February 8, 2019

RE: 16336 Shady View Lane

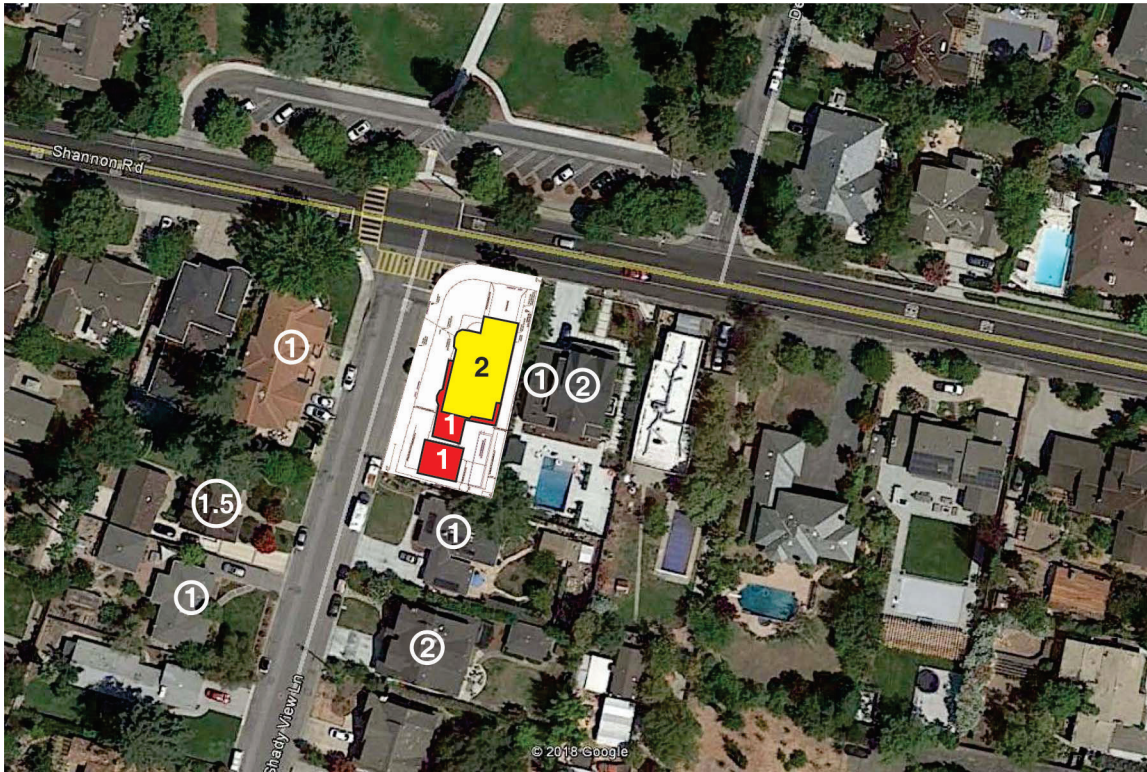
The proposed house is located on a corner parcel, and is largely two-stories in height - see illustration below.

The home is well designed in a Spanish Revival Style. I believe the main issue is the height and mass of the structure - especially at the corner of Shady View Lane and Shannon Road. It should be noted that there are different context conditions on each side of this parcel. Two specific issues are of note:

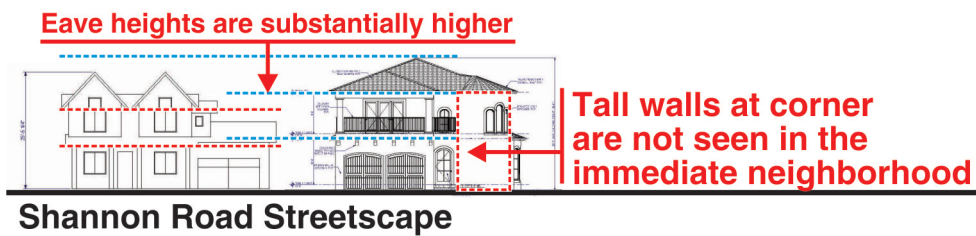
1. The eave and roof ridge heights are substantially taller than most homes in the immediate neighborhood.
2. The tall corner wall at the Shady View Lane and Shannon Road corner would be in substantial contrast to the strong first floor roof eave emphasis of homes in the immediate neighborhood.

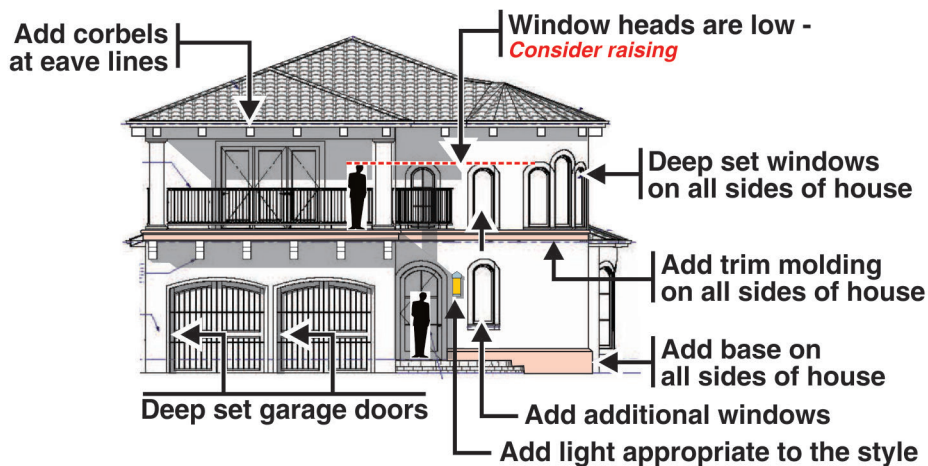
1. The tall corner facades with substantial blank wall area compared to the window areas could be redesigned to replace the round tower form with perpendicular wall planes, and a first floor eave and roof section carried around to both the north and west facades. However, the round stair tower is a common feature of this architectural style. Overall, the proposed design, while correct in general form, is short of the architectural details normally associated with the style. My recommendation would be to enhance the architectural details which would serve to mitigate the situation and divert attention away from the tall walls. These details could include the following:

- Additional windows at the corner on both the north and west facades.
Note: Second floor arched window heads appear to be lower than eye level, and consideration should be given to raising them.

- Decorative wood corbels at eave lines.
 - Trim molding on all sides of the house at the second floor line.
 - Deep set garage doors and all windows on all facades - see example photo below.

- Projecting stucco base on all sides of the house.
 - Add a decorative carriage light consistent with the architectural style at the entry door.
 - Make the second floor columns on the north balcony square. They are now shown with a wide face on Shannon Road and a narrower face on Shady View Lane
